TOWN OF BROOKLINE

PURCHASE ORDER CHANGE FORM

FOR: Brookline High School - Third Floor and Quad Renovations

CHANGE ORDER NUMBER: 006
DATE: 11/03/2022
ARCHITECT'S PROJECT NO.:
CONTRACT DATE: March 29, 2022
CONTRACT FOR: 3rd Floor Renovation & Quad Repairs

STEP 3

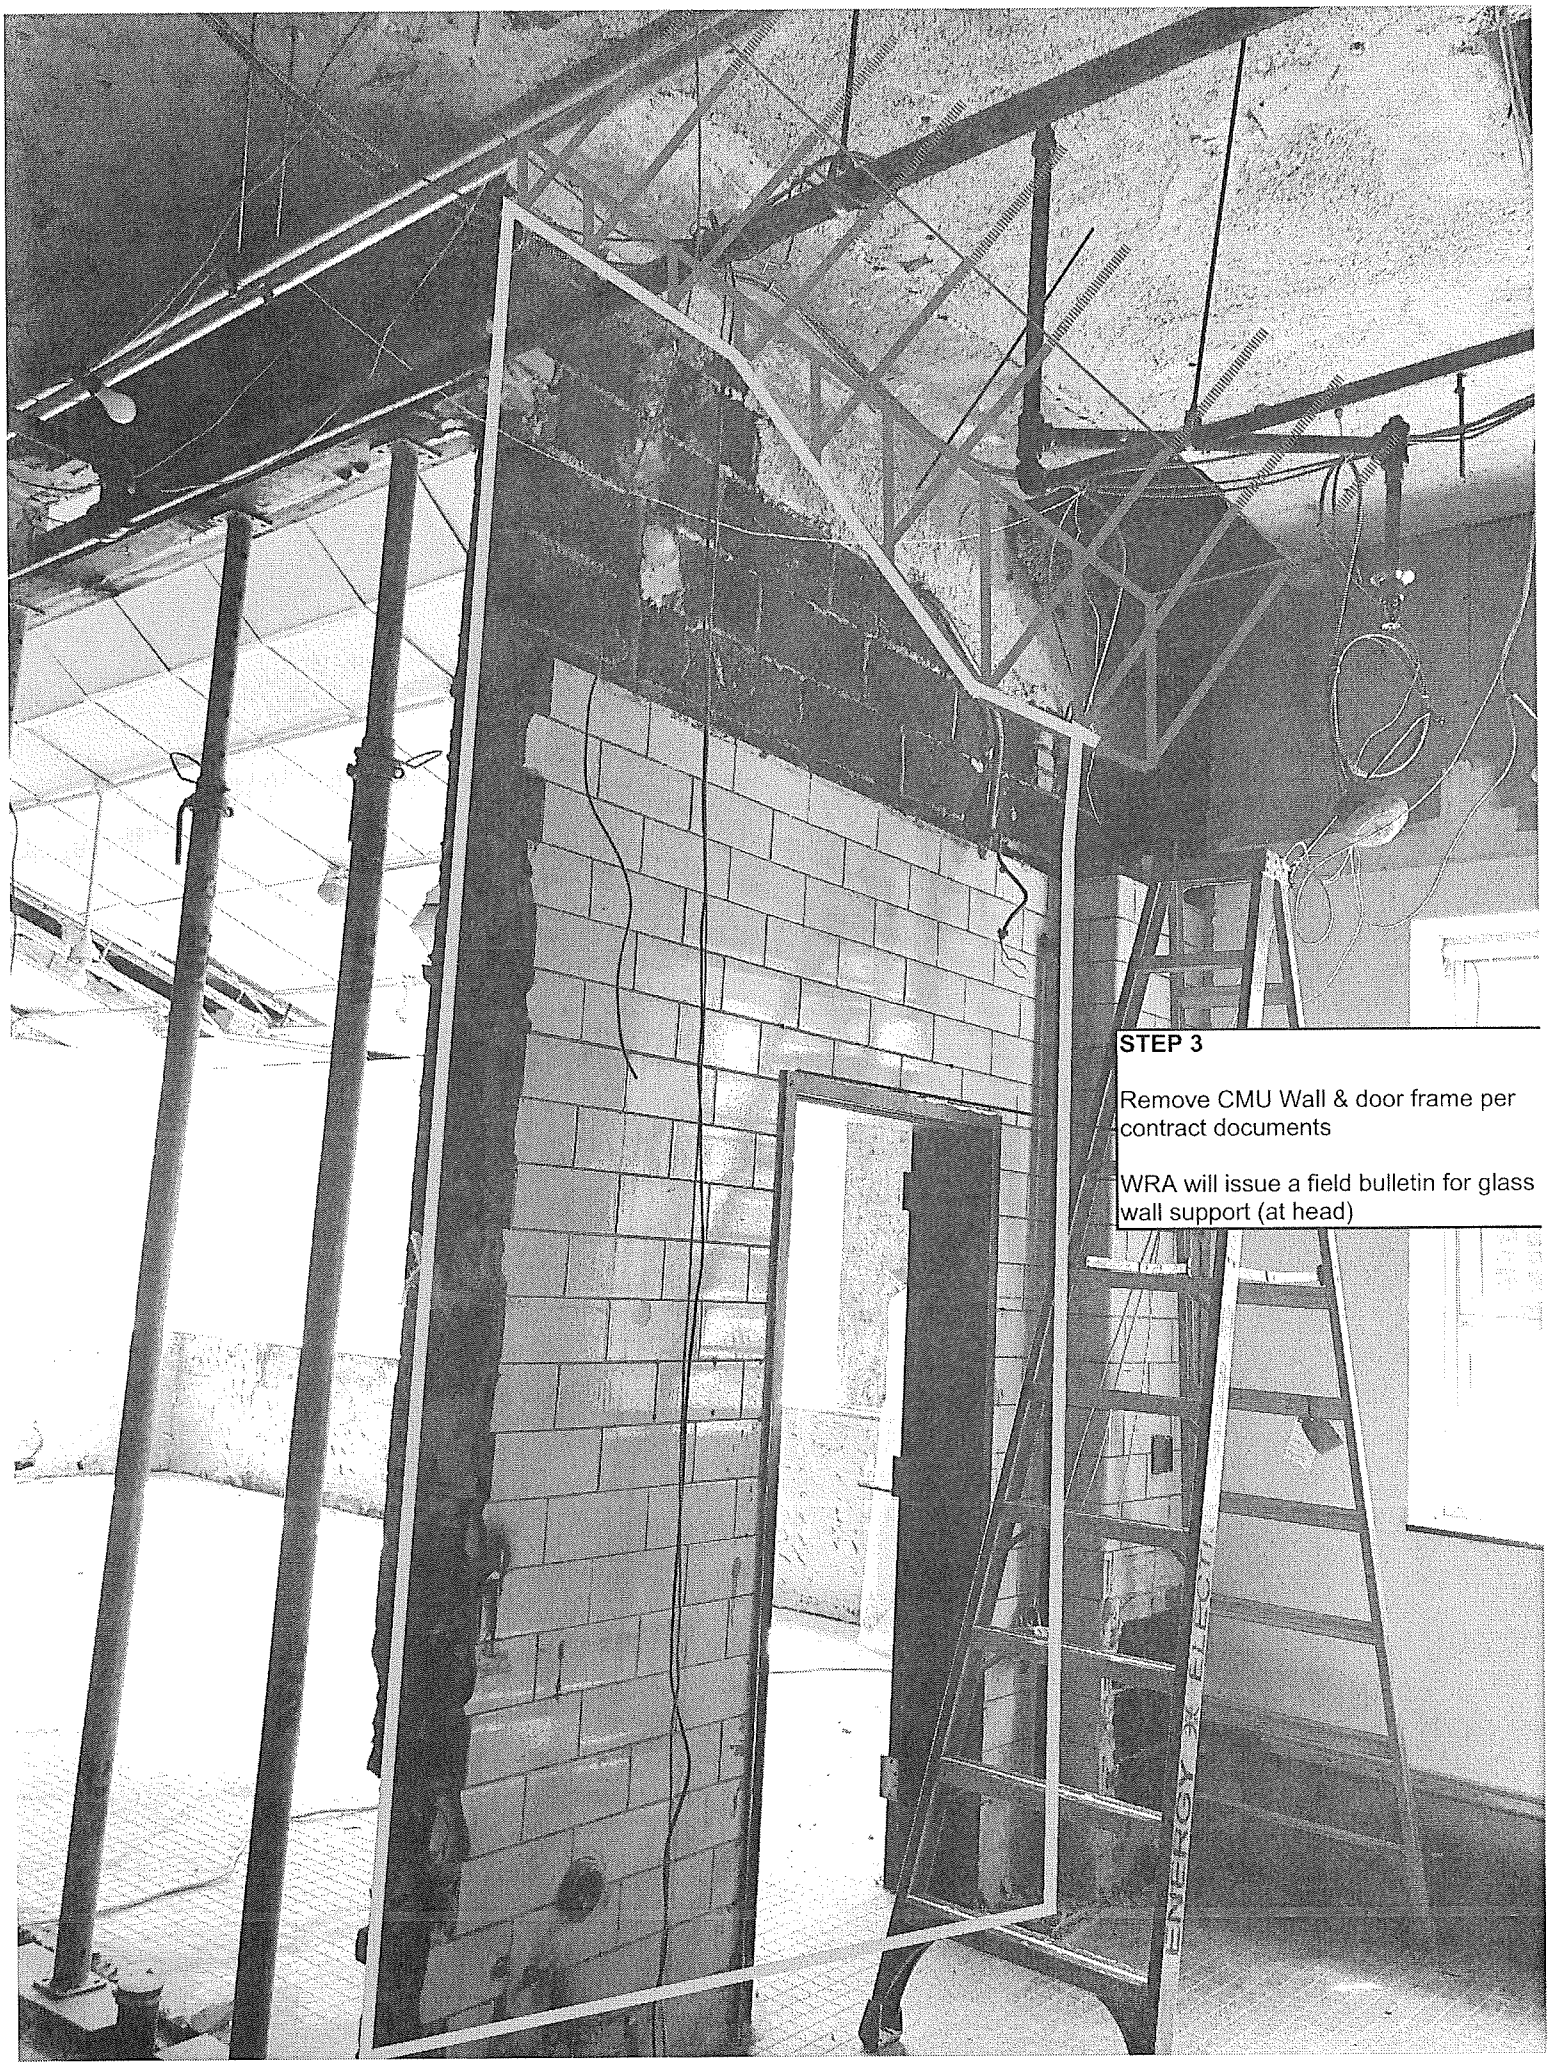
WRA Response: See comments on the attached photos. WRA comments are in blue and yellow.
- Andy Jonic
5/13/22

STEP 1
REMOVE PLASTER CEILING AND PLASTER ON WALL TO EXPOSE THE WOOD FRAMED EXTERIOR WALL
LeM 5-13-22
Shore end of C-channel at end supported on top of existing wall to be removed as discussed on site. A new L4x4x3/8 hanger should be added to the top of the existing channel at end. Weld to C channel and roof framing with 5/16" fillet all around.

LeM 5-13-22
2. At partion wall to be removed;
The existing perimeter wood stud wall is supported by the masonry wall to be removed. Add CFMF back-up framing hanger studs behind each existing wood stud. Hanger studs should be attached to roof framing above. Brace bottom of each hanger with CFMF kicker. Remove existing wall after installation of CFMF.
Masonry Wall (CMU

Remove CMU Wall & door frame per contract documents

1 E003 SITE PLAN
SCALE: 1"=10' = 1'-0"

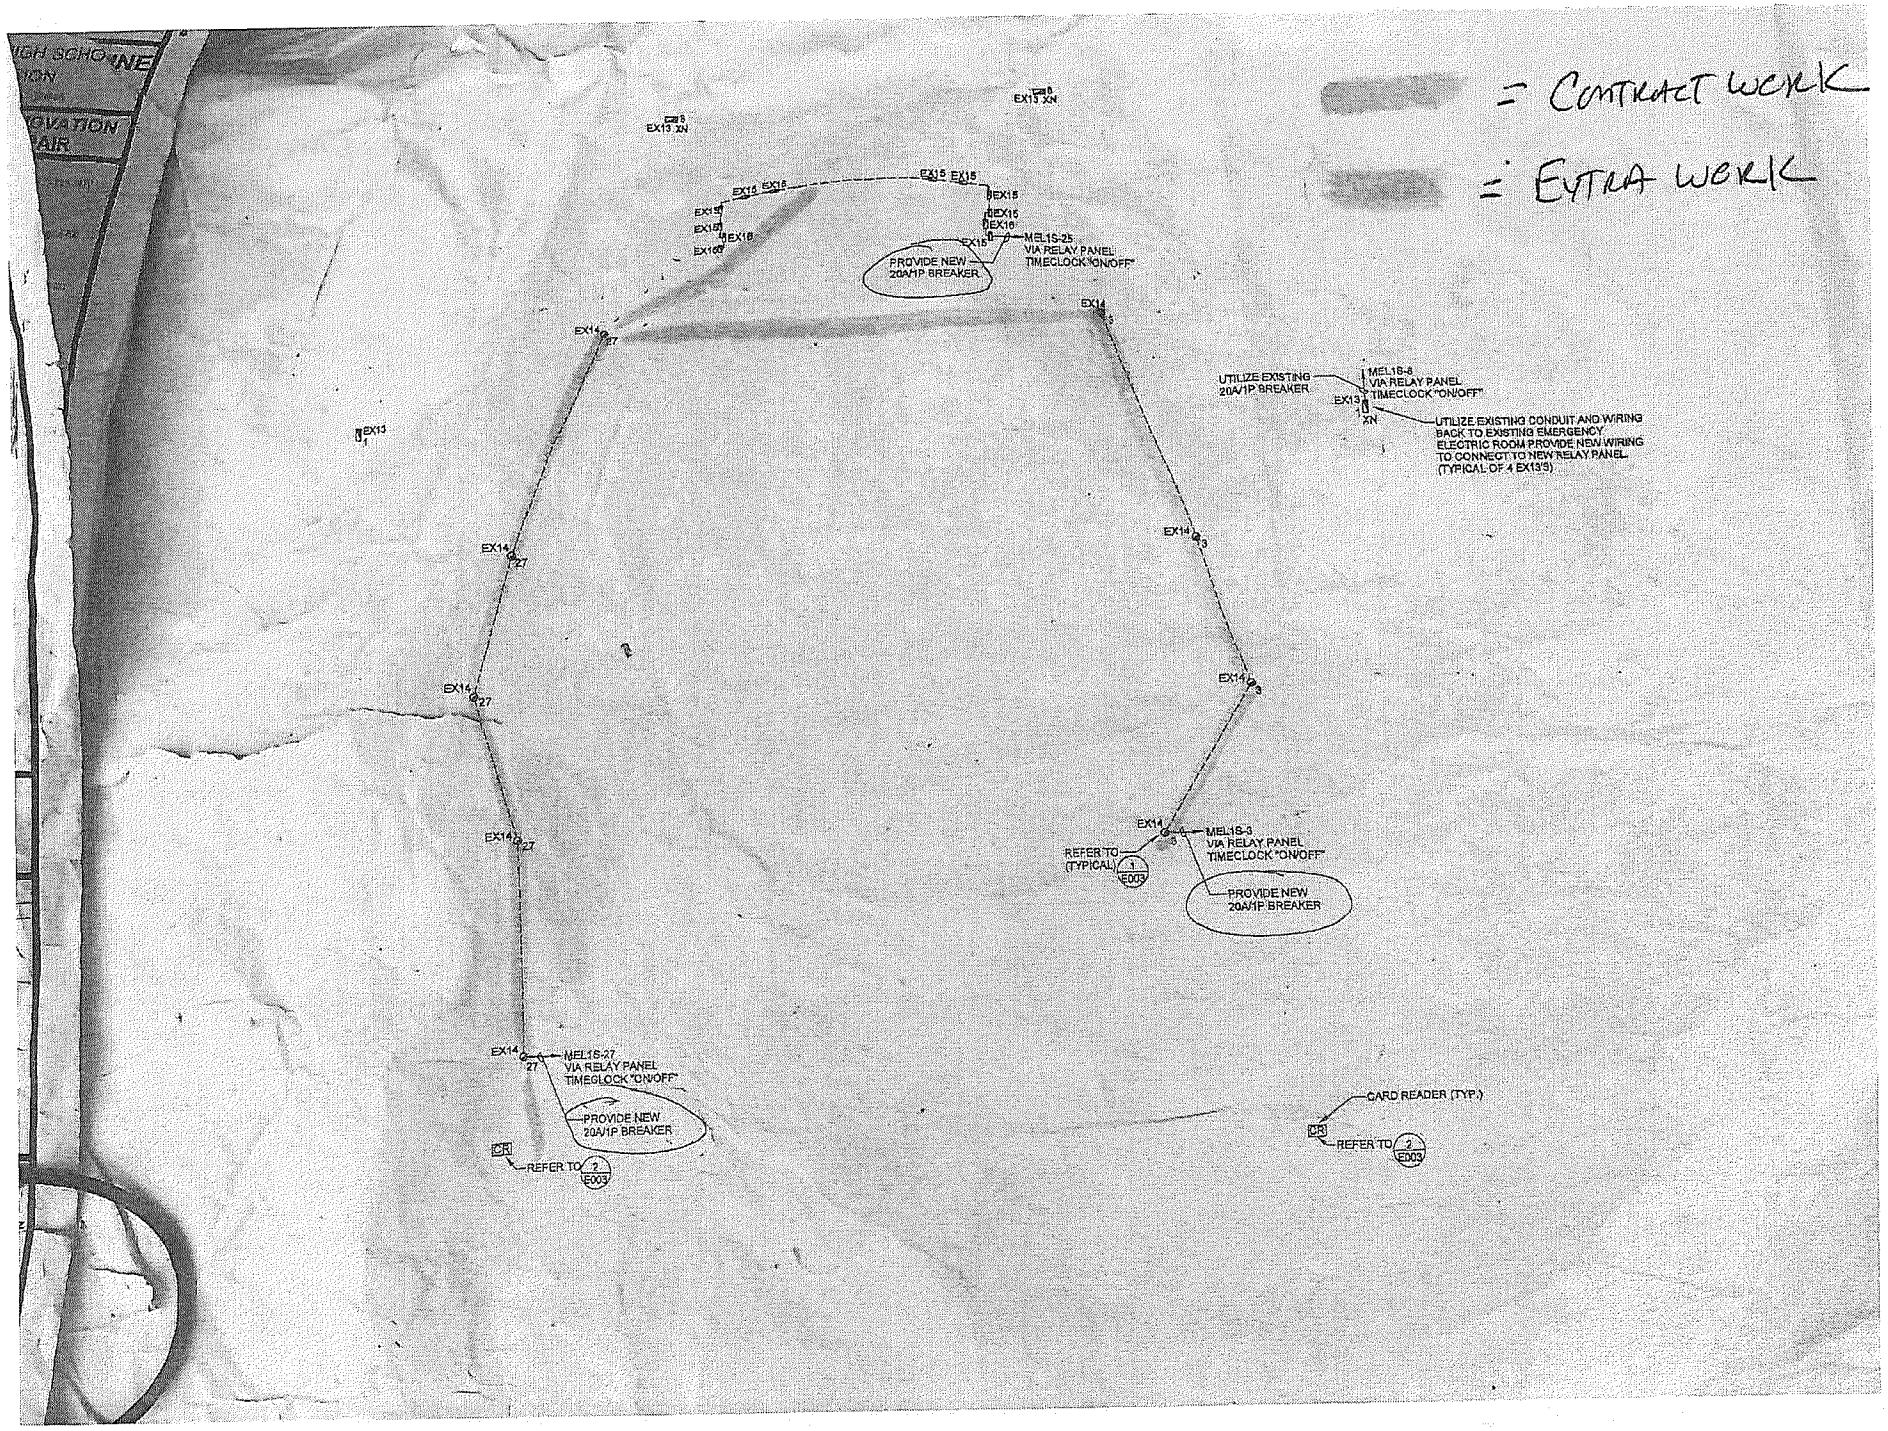
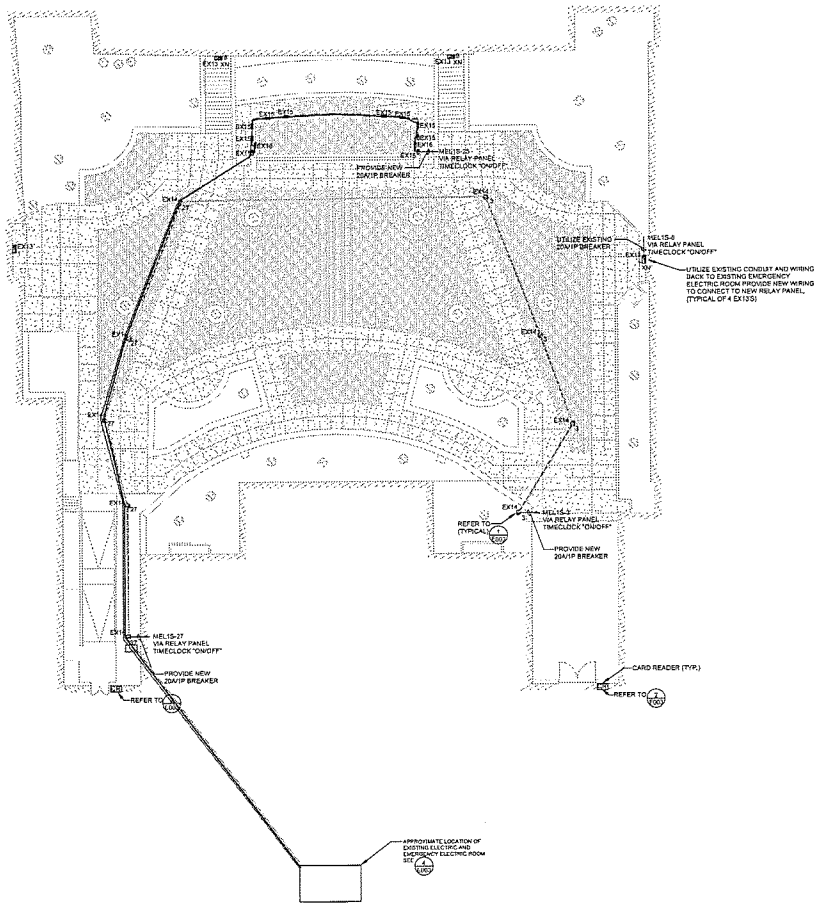
= EXTRA WORK
